TO: MUNICIPAL MANAGER  
FROM: APPROVING OFFICER  
SUBJECT: SUBDIVISION REFERENCE #72/91  
D.L. 57, Lot 278, Plan 35621  
2820 Underhill Avenue  
SEARS WAREHOUSE SITE

PURPOSE: To obtain Council approval for the piping of portions of two watercourses traversing the subject site.

ITEM	6
MANAGER'S REPORT NO.	70
COUNCIL MEETING	91/12/09

S. D. REF. # 72/91  
 X. REF. S. D. REF. # 39/83  
 123

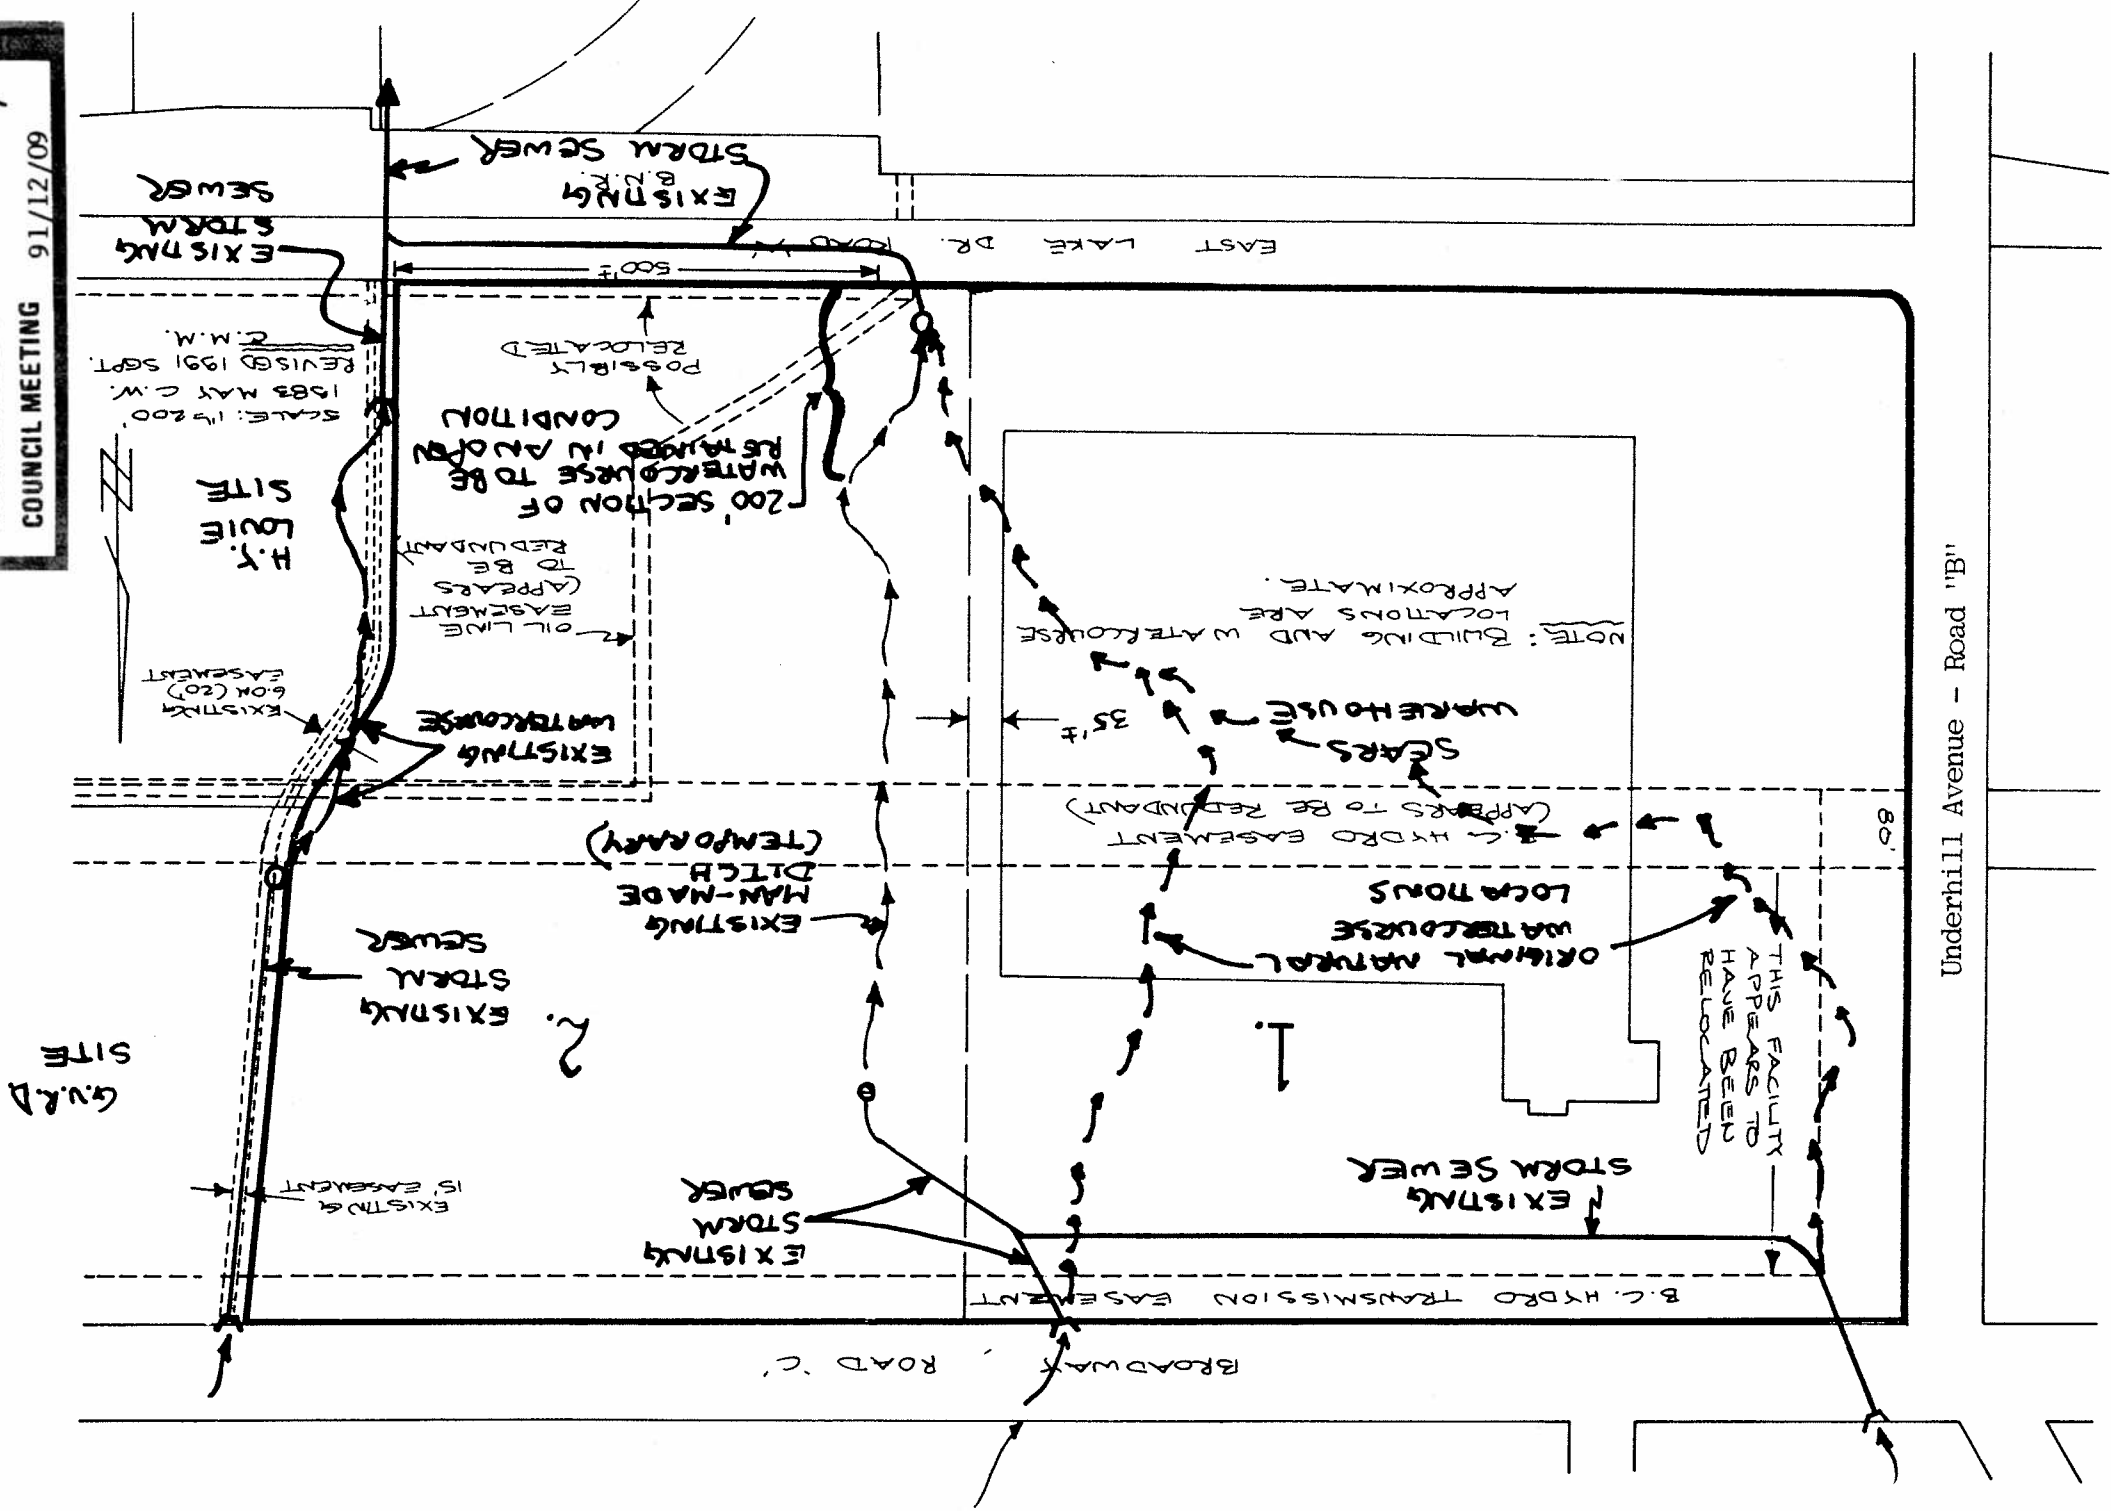
3.1 The Planning and Building Department recommends leaving the southerly 200 feet of the westerly watercourse in its current open and natural condition with minimal disturbance to the existing trees and vegetation and that the subdivider have a tree survey completed identifying existing trees. This section of the watercourse appears to be stable without the slope failure problems noted in Section 2.2 above.

- 3.3.1 The developer is to retain a geotechnical engineer to assess the stability of the ravine slopes in this area and make appropriate recommendations for stabilization if necessary.

- 3.3.2 The developer will be responsible for the design and construction of appropriate outfall structures and energy dissipation structures for the portion of watercourse which is being recommended for enclosure to the north of this open section.

- 3.3.3 The developer will be responsible for designing and constructing a permanent inlet structure complete with trash screen north of Eastlake Drive plus any localized rip-rapping or other form of erosion protection as needed within the open section.
